DEPARTMENT OF THE ARMY  
JACKSONVILLE DISTRICT CORPS OF ENGINEERS  
P. O. BOX 4970  
JACKSONVILLE, FLORIDA 32232-0019

Regulatory Division  
199404532 (IP-BB)

Modification#2

Stormwater Treatment Area 2  
including  
S-5A Basin Runoff Diversion

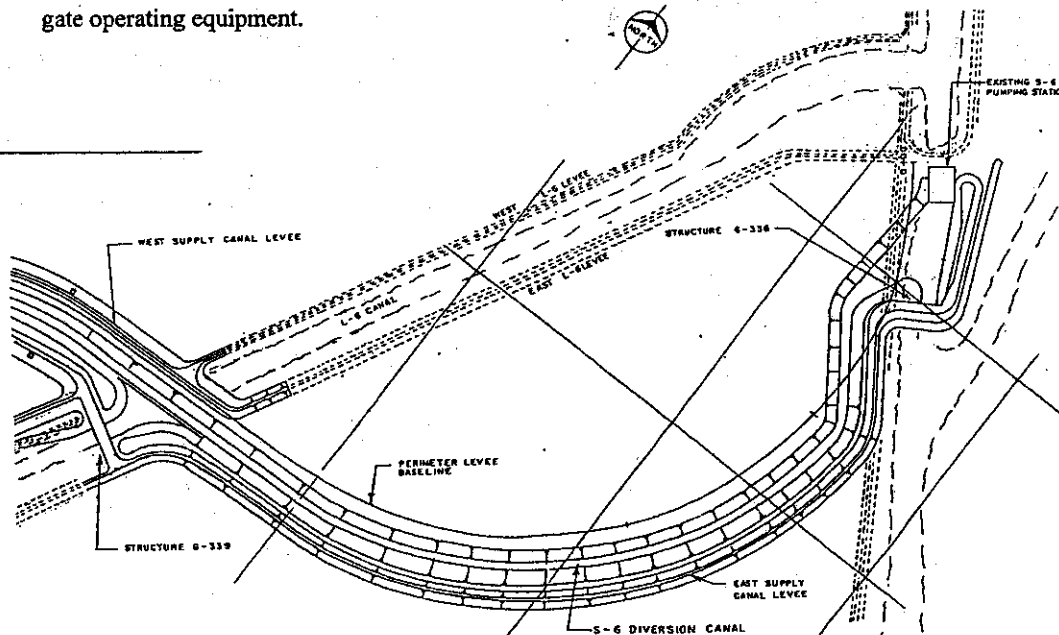
The enclosed four pages hereby replace pages 10, 11, 12, and 18 of the 60 pages attached to the permit instrument. The drawings delete the construction of a canal within Water Conservation Area 2A that would connect the hydropattern restoration component of Stormwater Treatment Area 2 to the Hillsboro Canal.

This replaces drawing page 10 of 60  
that was dated MHA 10 197 and attached  
to U. S. Army Permit# 1994 04532.
